**APPEAL APPLICATION**

Appellant's Name (print): John P. Biestman Phone: 506 747.8798
Mailing Address: 61379 Lost Hollow Loop City/State/Zip: Bend, OR 97702
Email Address: john.biestman@gmail.com
Land Use Application BeingAppealed: 247.22.000415.MC.416.SP
Property Description: Township 18 Range 11 Section 12CC Tax Lot 03400
Appellant's Signature: J.P. Biestman

Exhibits to Appeal Application for Land Use Application
247-22-000415-MC-416-SP

Land Use Action Comment 247-22-000415-MC-416-SP

Catchment basin adjacent
to Proposed Land Use

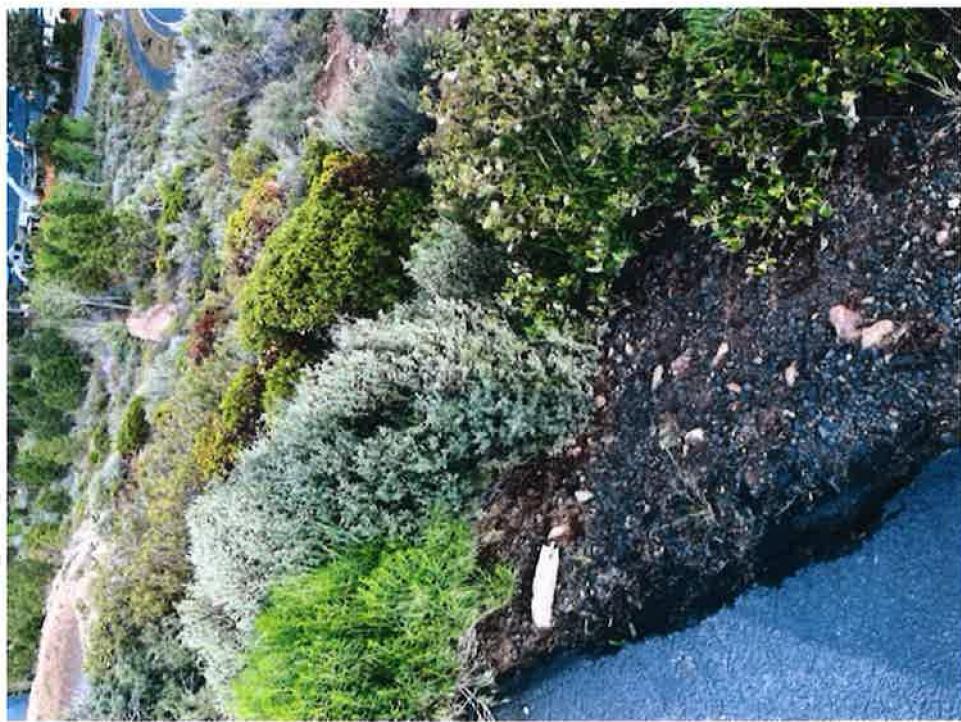
June 13, 2022, 10 days after rain event,
The catchment basin remained full.

Three weeks after the rain event, drains were pumped around the neighborhood. How often are they maintained?

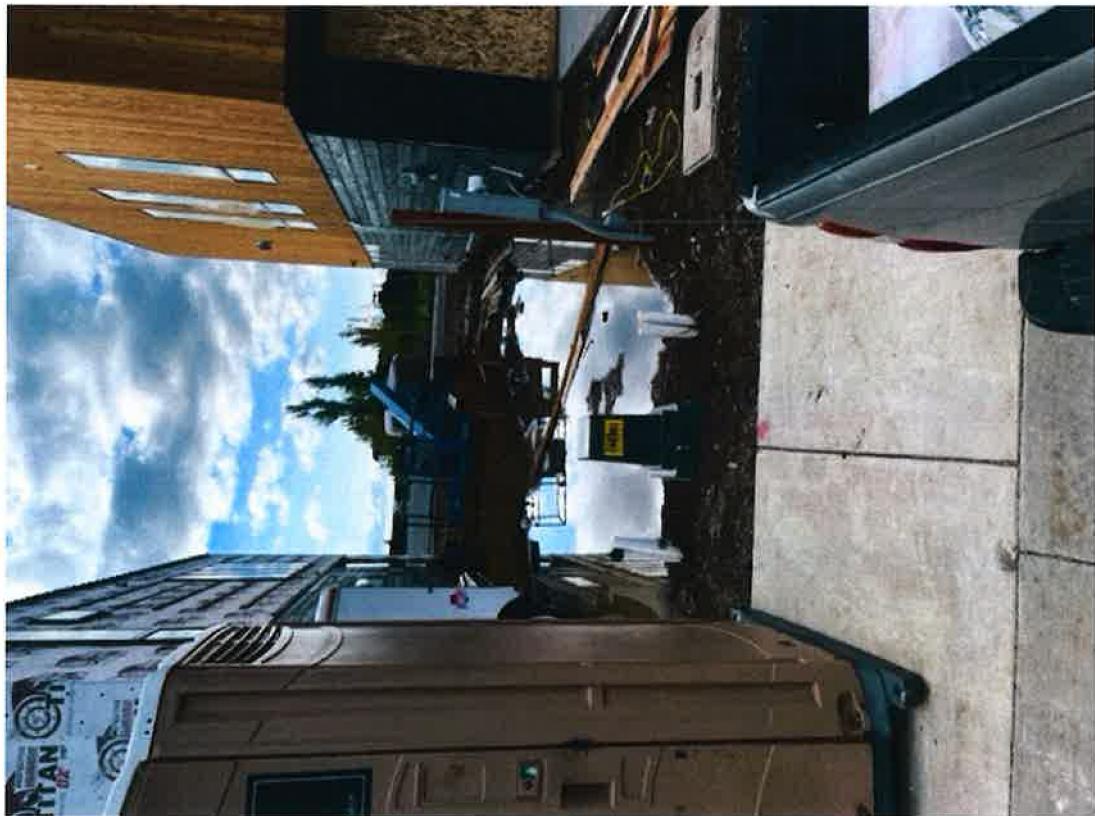
June 13, 2022. Evidence of erosion the south side of Meeks Trail, directly across the street from the proposed site of land use.

June 13, 2022. Evidence of remaining flooding on the south side of Meeks Trail, across the street from the proposed site of land use.

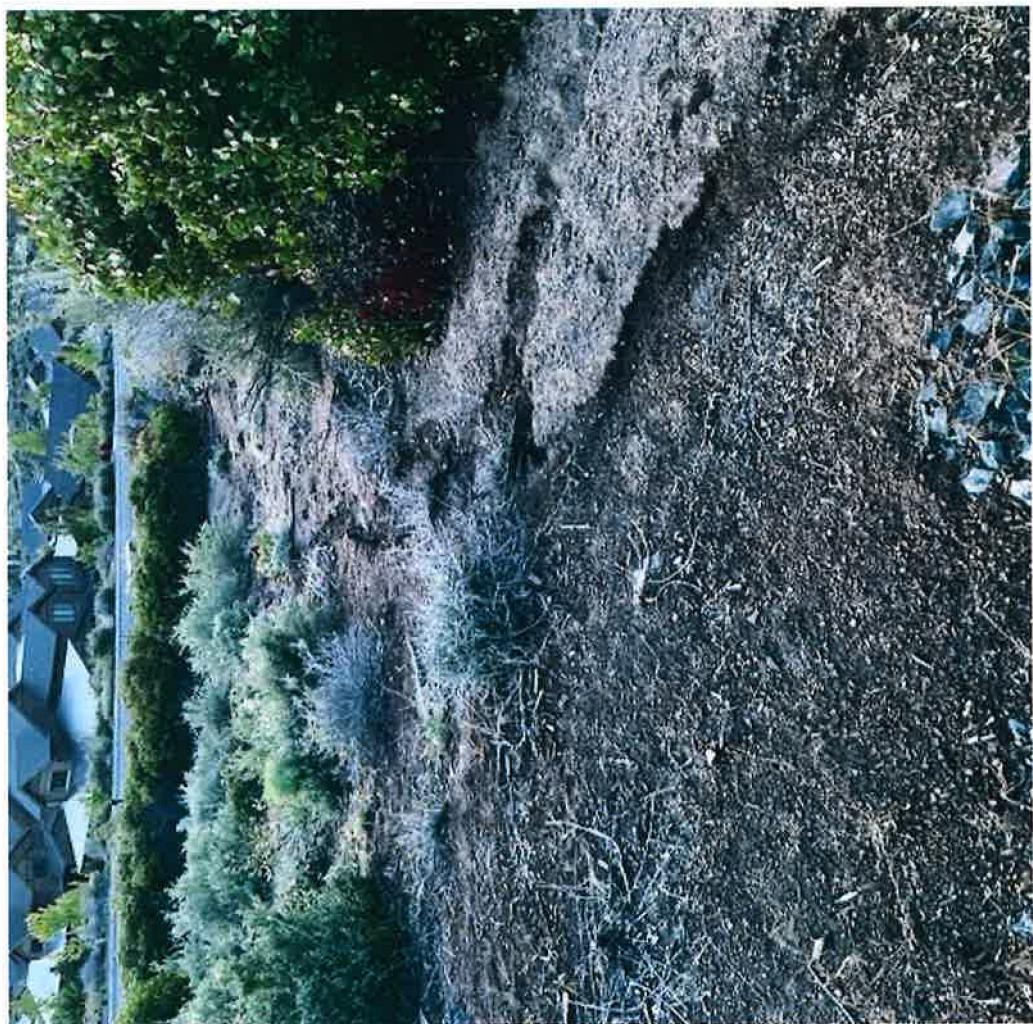
Evidence of erosion Lost Hollow Loop and Meeks Trail. A pattern?

Unmitigated and longstanding median runoff from Meeks Trail. A pattern?

Evidence of erosion from Tetherow Vista. No catchment infrastructure. A pattern?

Upstream Drainage Analysis

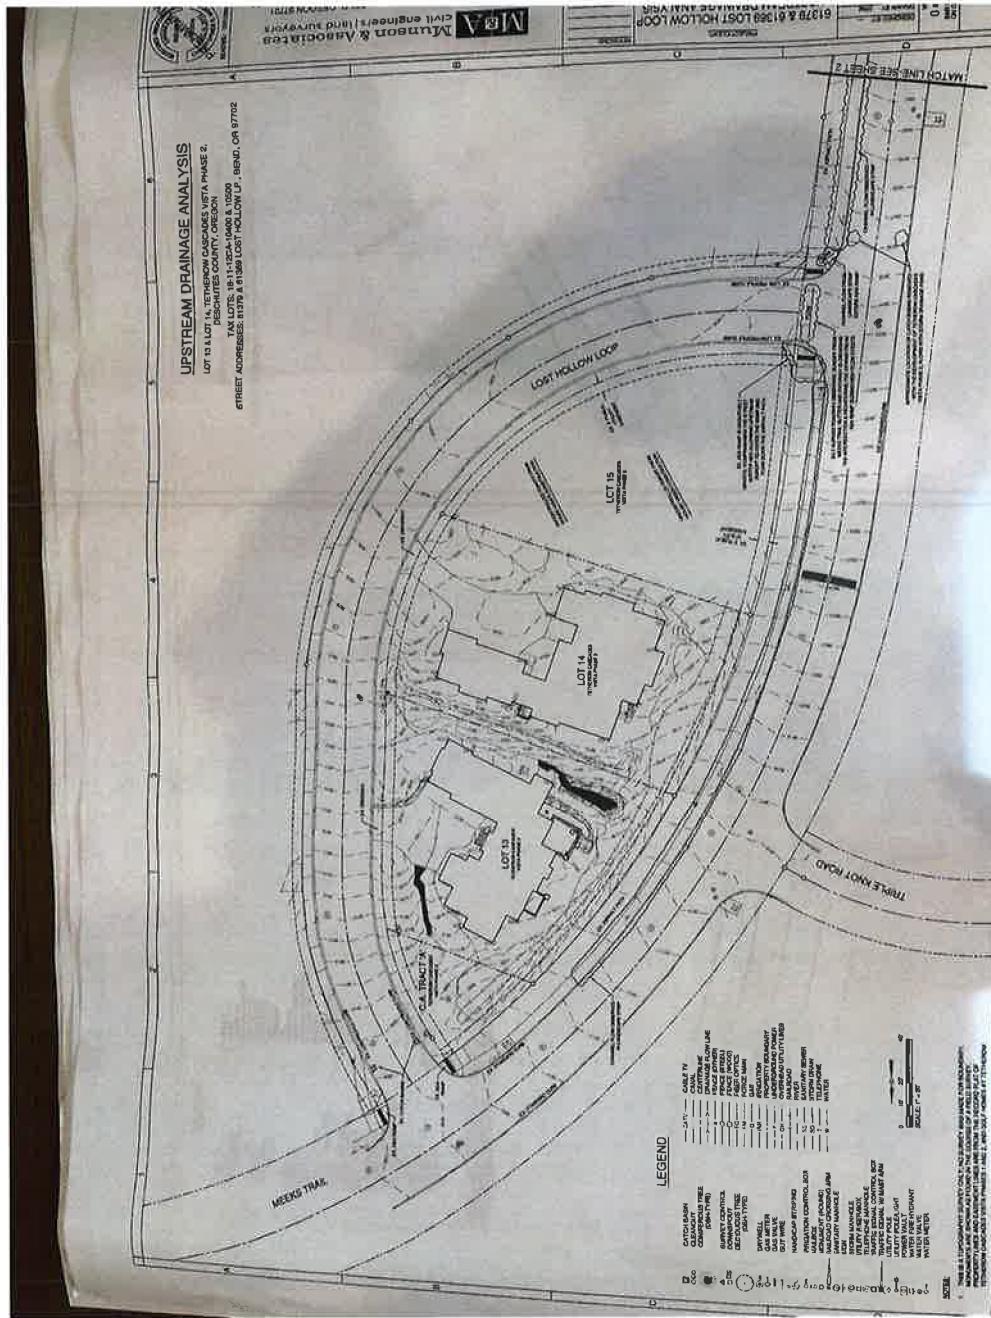
Findings on Upstream Drainage Analysis

- ADA ramp is negatively graded compromising the street gutter and allowing the upstream runoff to enter the ramp and flow down the asphalt path and into residents' yards
- Catch basins were removed with the development of Tetherow Cascades Vista Phase 2, along with the storm Drainage pond, presently occupied by CV15
- Channel flow observed in eroded median strips

Upstream Drainage Analysis

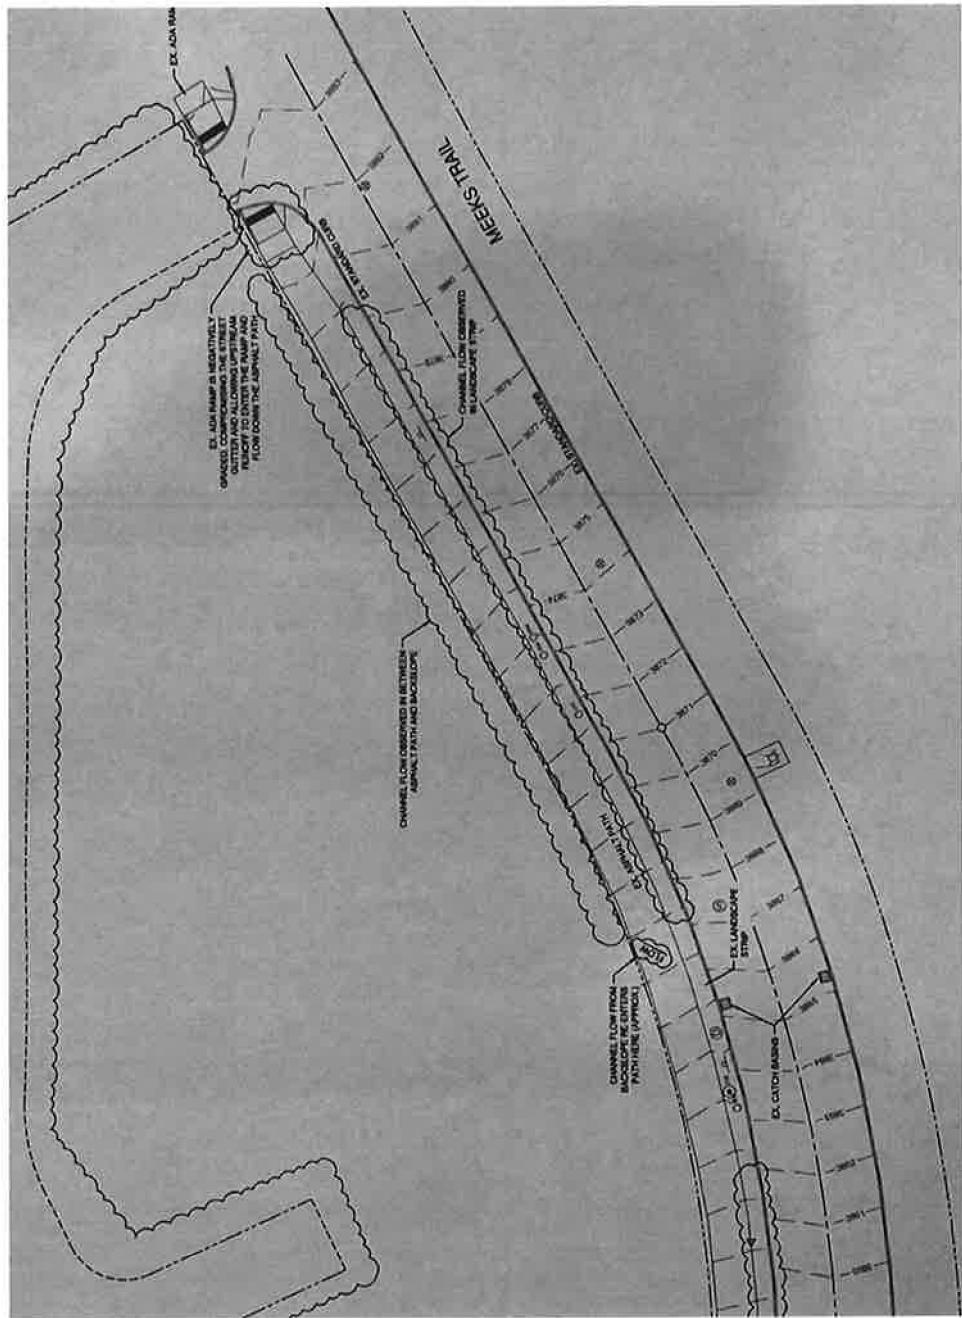
Findings on Upstream Drainage Analysis

- Uncontrolled runoff (channel flow) observed from Tetherow Vista Drive
- ADA ramp is negatively graded, compromising the street gutter and allowing upstream runoff to enter the ramp and flow down the asphalt path
- Channel flow observed in between asphalt path and backslope
